# ***SOMERSET NORTHERN BYPASS PULASKI COUNTY, KENTUCKY***

Item Number 8-59.60

**VALUE ENGINEERING STUDY  
for  
Kentucky Transportation Cabinet  
Frankfort, Kentucky**

**Final Report**

## VALUE ENGINEERING DESIGN COMMENT # VE-3

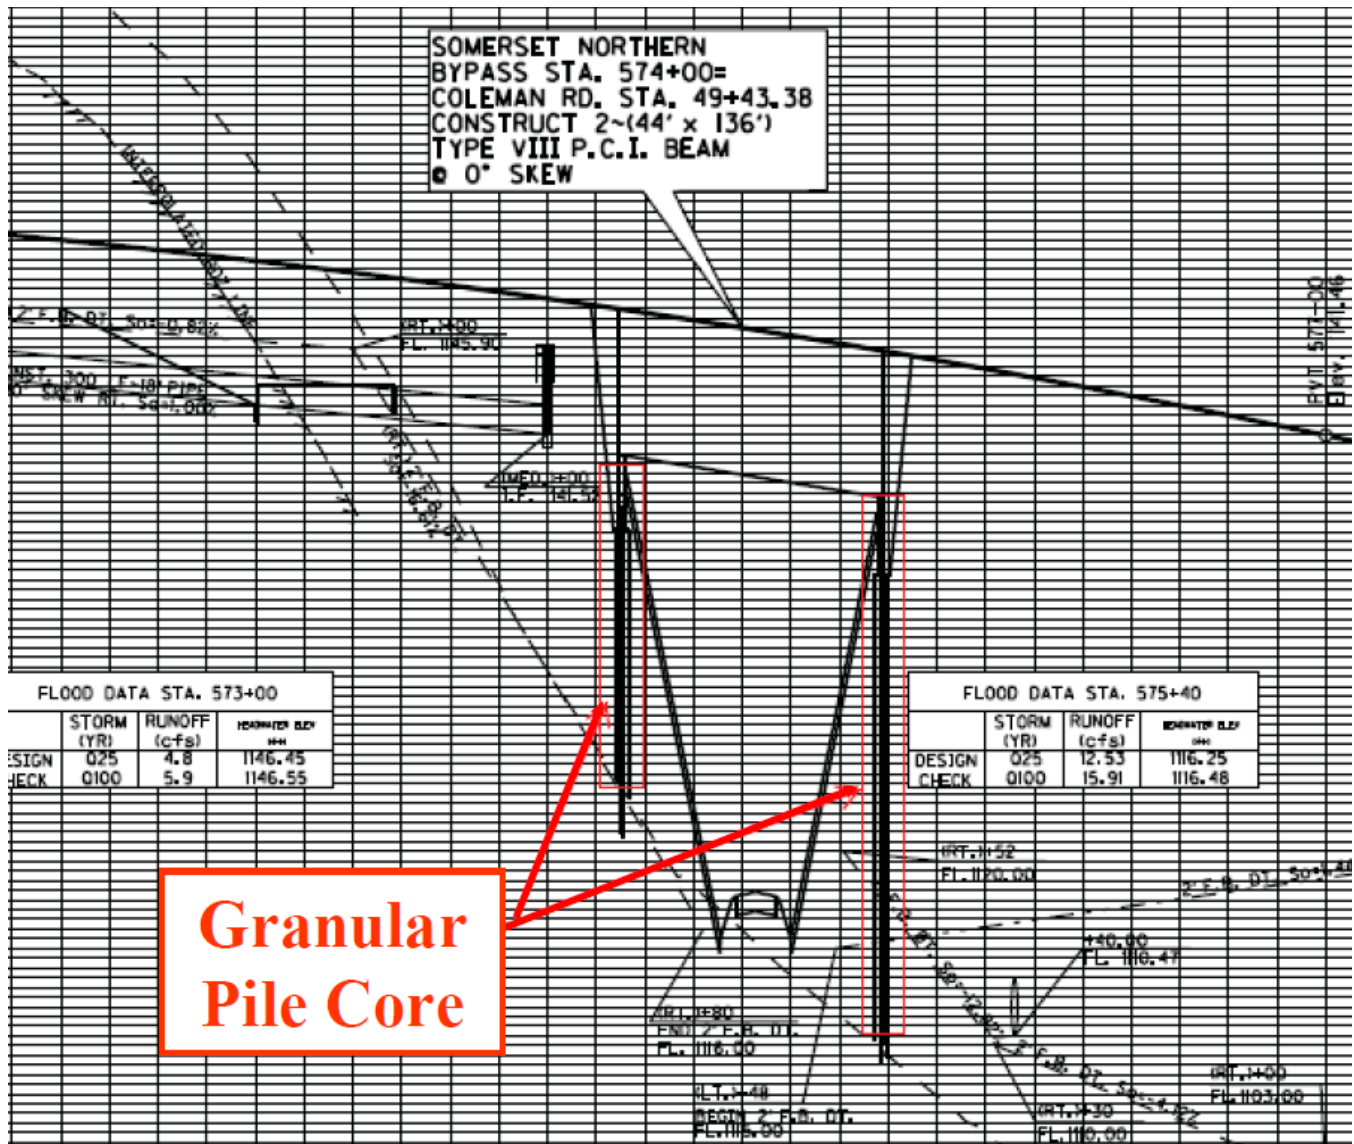
Eliminate \$2,604,625 from cost estimate for Rock Roadbed.

Eliminate bid item from project cost estimate for Rock Roadbed. As currently designed this project's earthwork is paid as Roadway Excavation. Therefore, suitable rock from cuts on project is to be used for the rock roadbed. Generally for this situation, KYTC requires that the work related to the rock roadbed be made incidental to the Roadway Excavation bid item. It is recommended that a note be included in Plans (Geotechnical Notes or General Notes) to clarify this issue.

## VALUE ENGINEERING RECOMMENDATION # VE-6

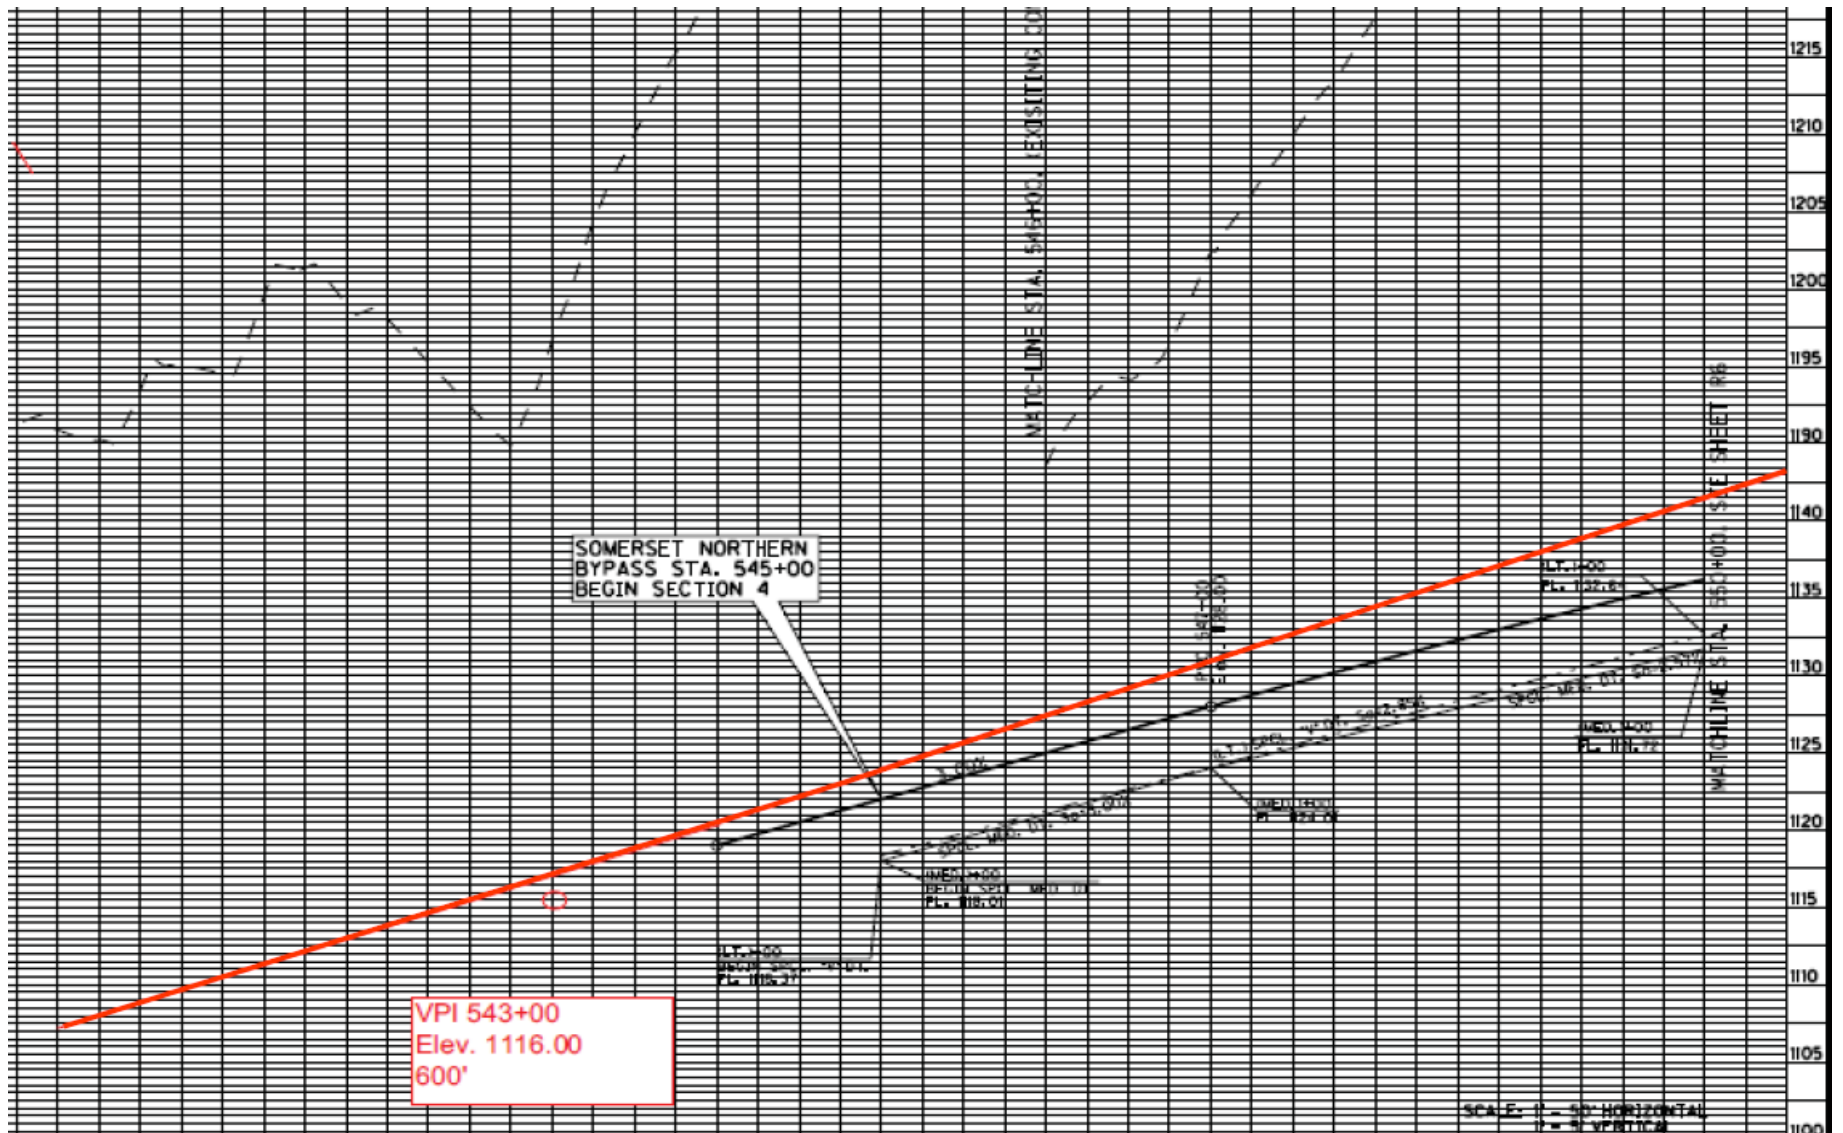
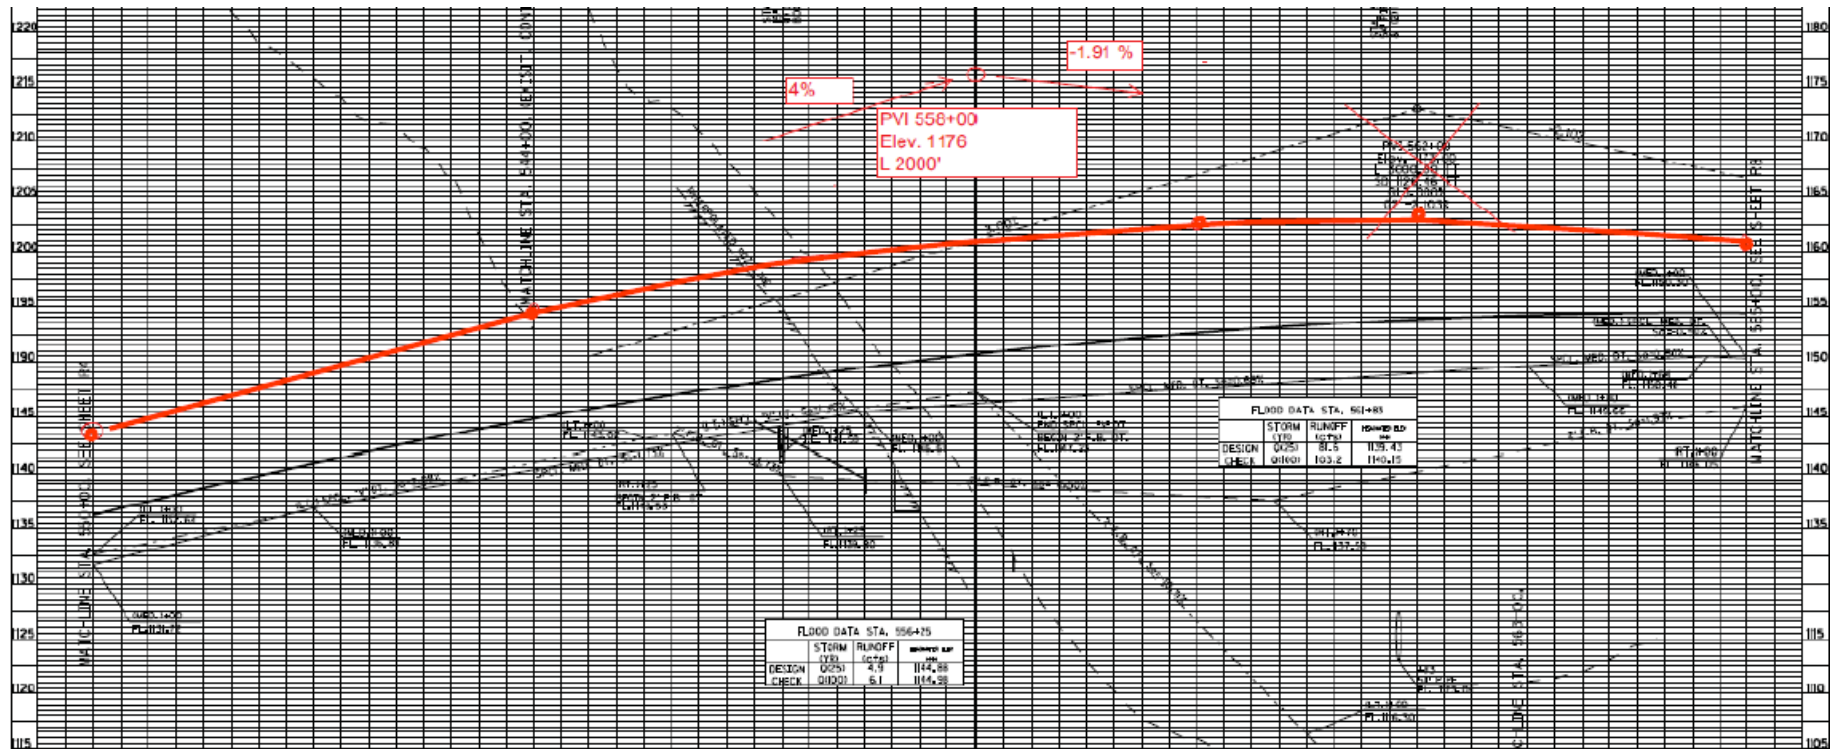
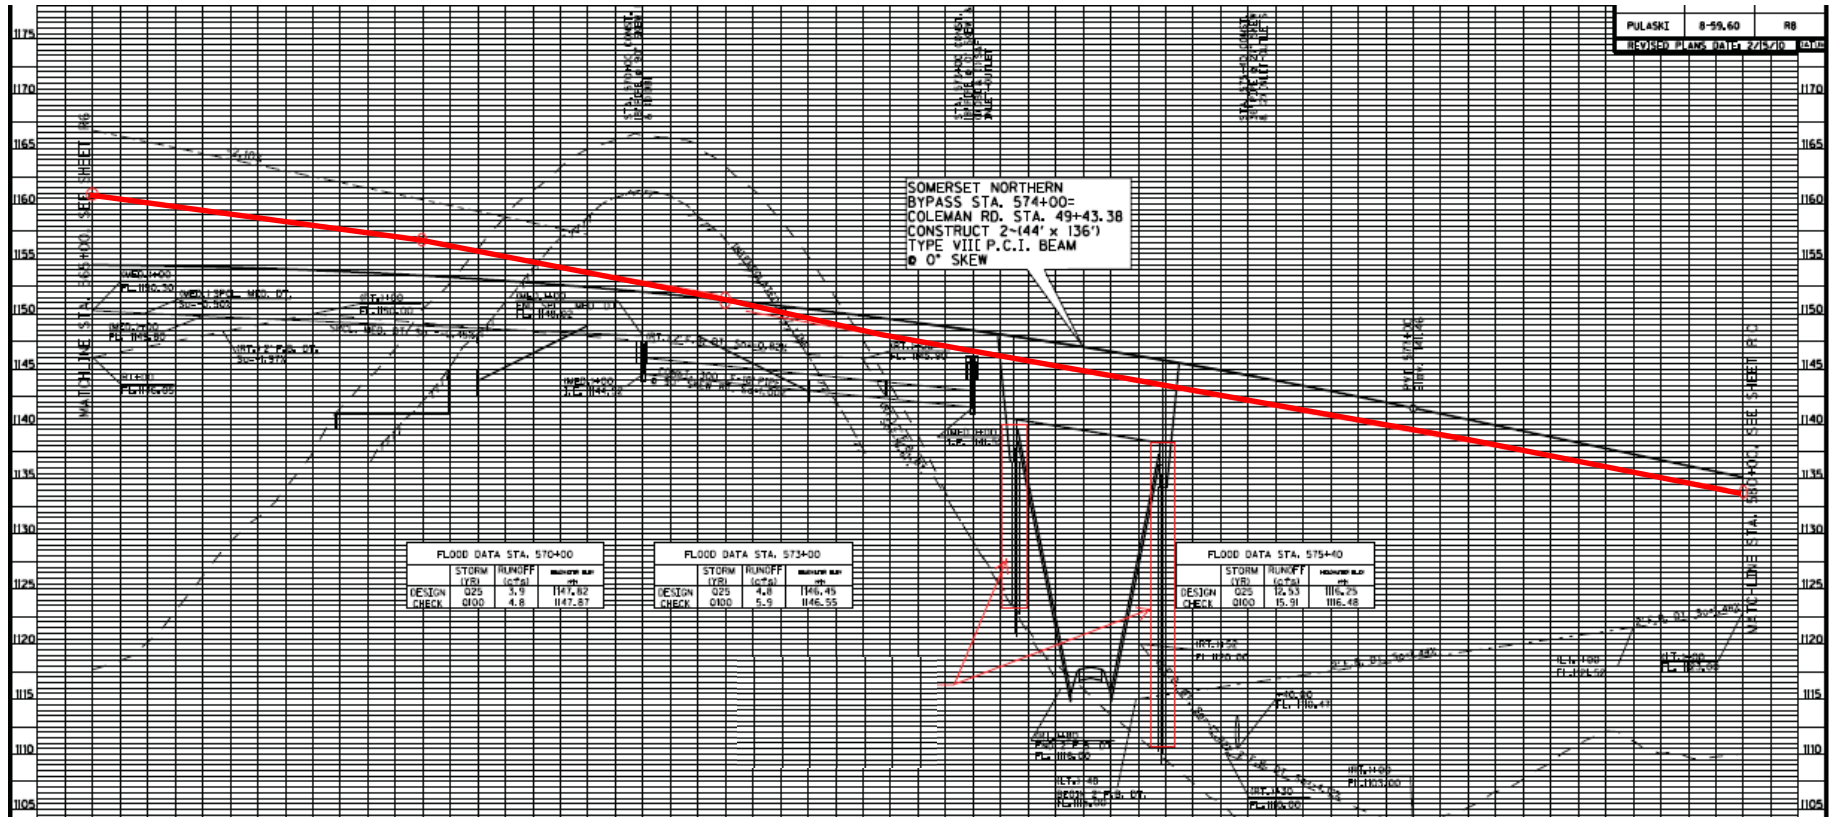
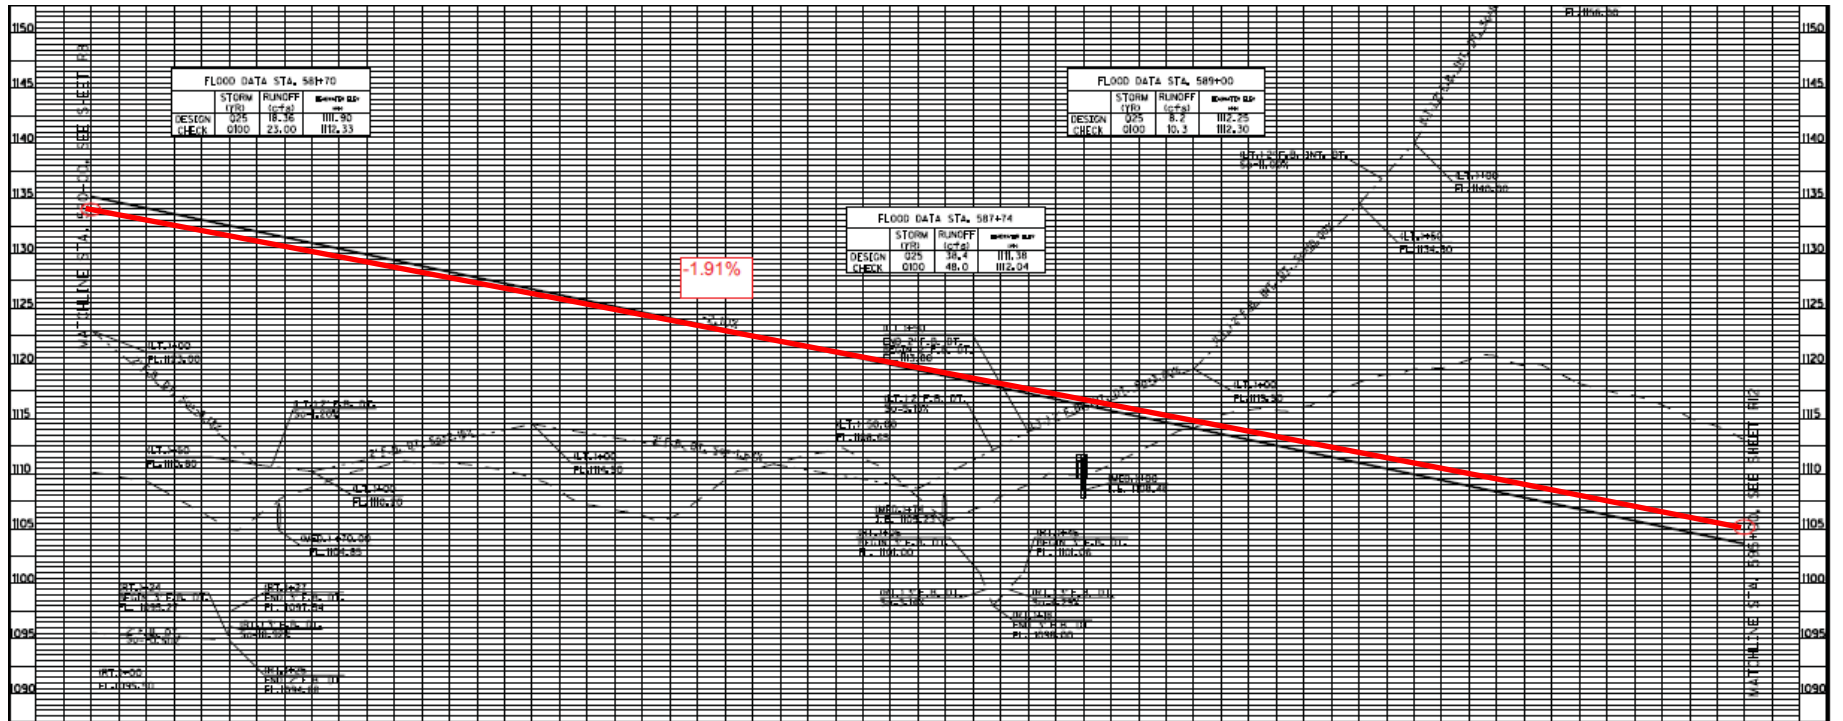
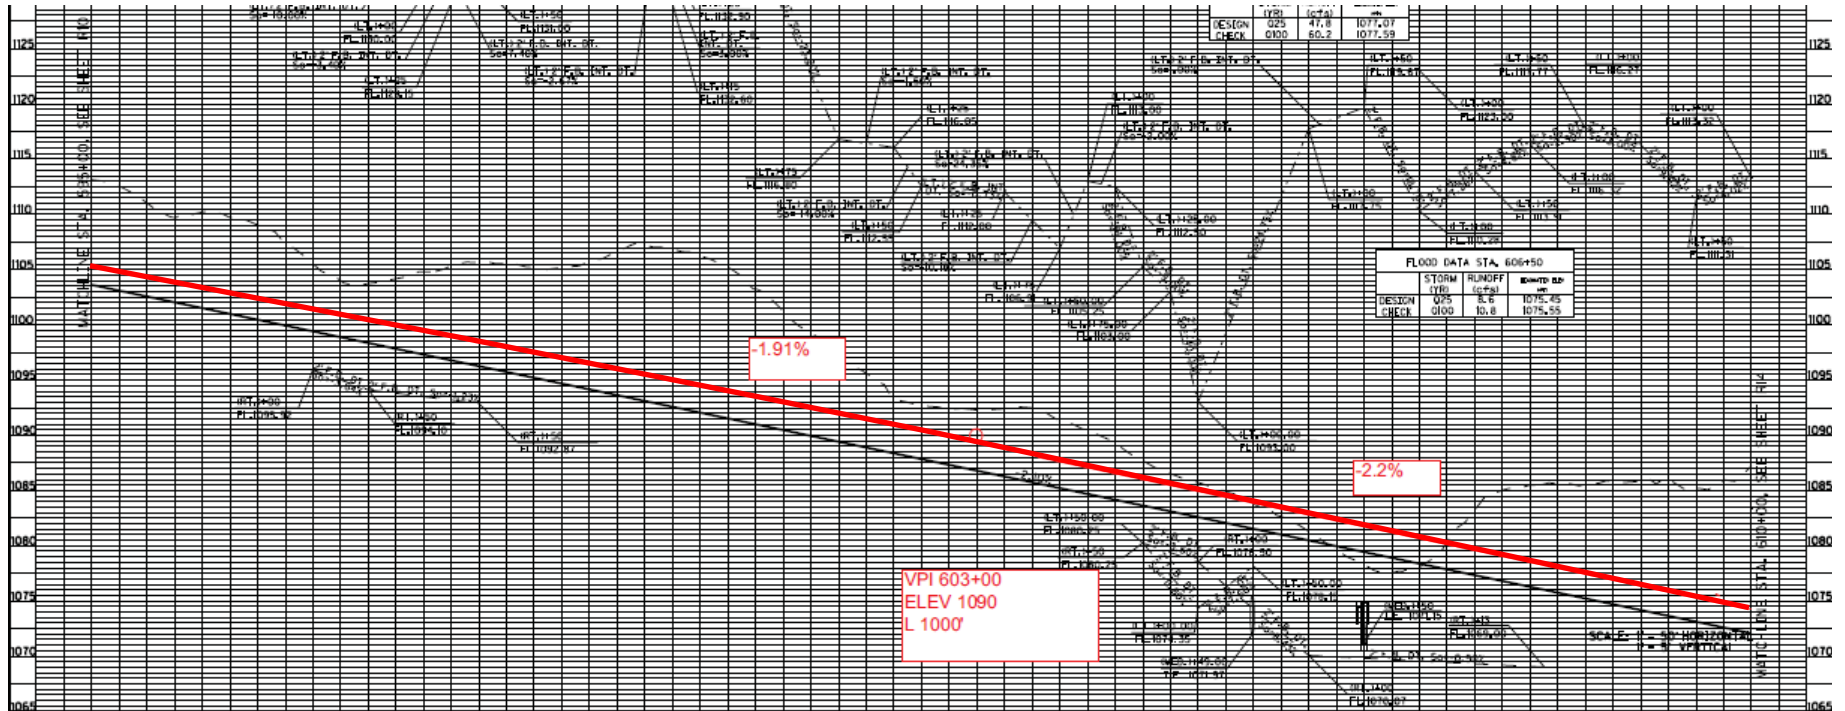
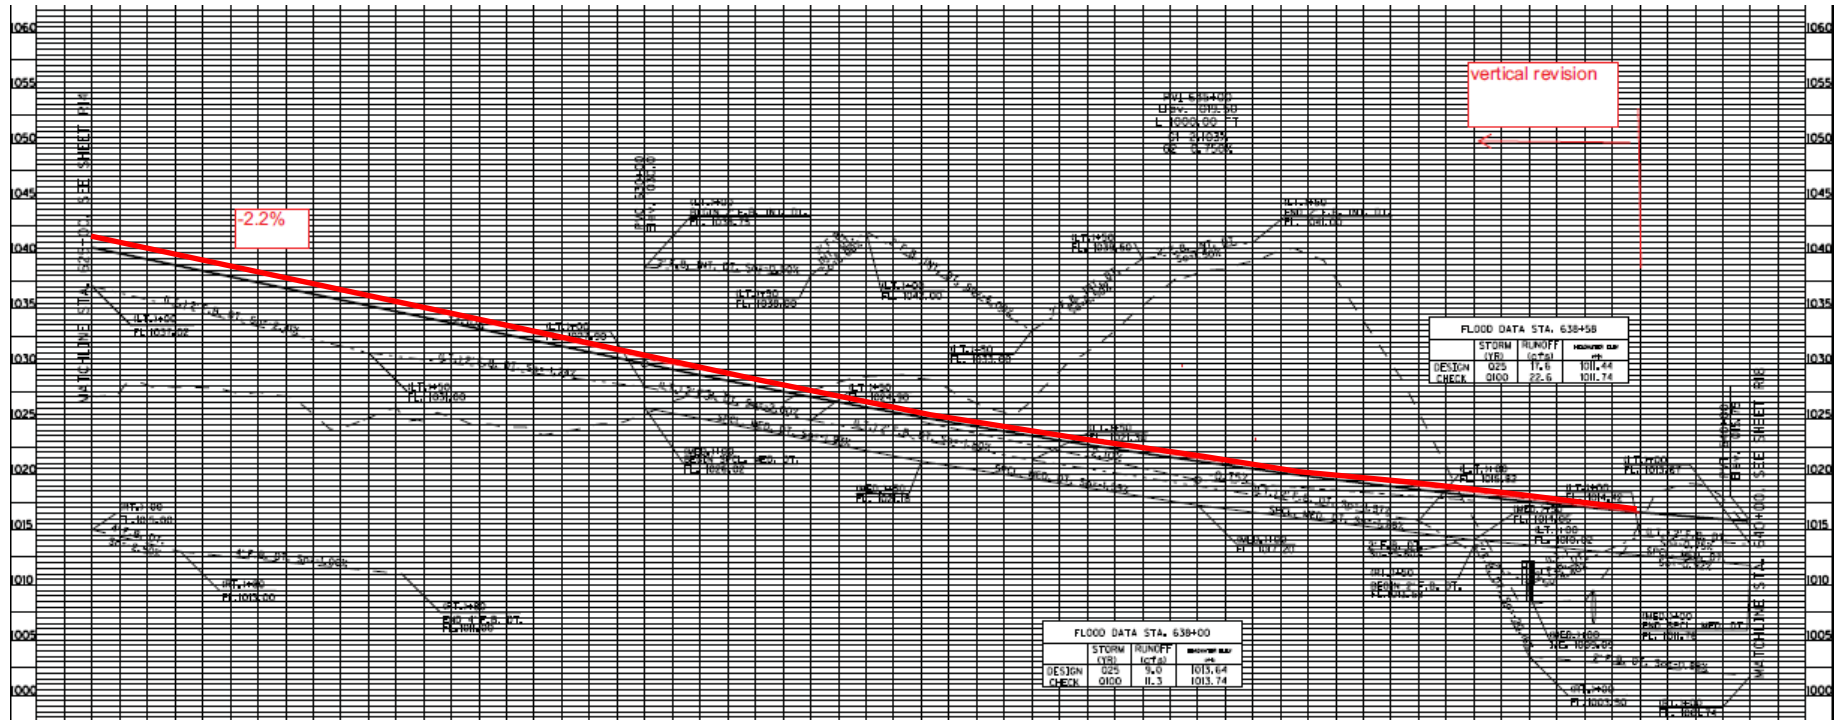
Revise profile grade in order to minimize excavation.

The VE team recommends revising the vertical alignment on Section 4A to raise the grade through the two major cuts on project. In this study the profile grade is changed from beginning of project to Station 638+00. This would reduce roadway excavation by approximately 125,500 cubic yards. The quantities included in this study are based on **only** one alternative vertical alignment. A further in-depth evaluation of different vertical alignment adjustments will possibly provide more decrease in total excavation and better overall earthwork balance. The proposed revision does also raise grade in embankment area from approximately Station 557+00 to Station 566+00 which will require additional right-of-way in this section.
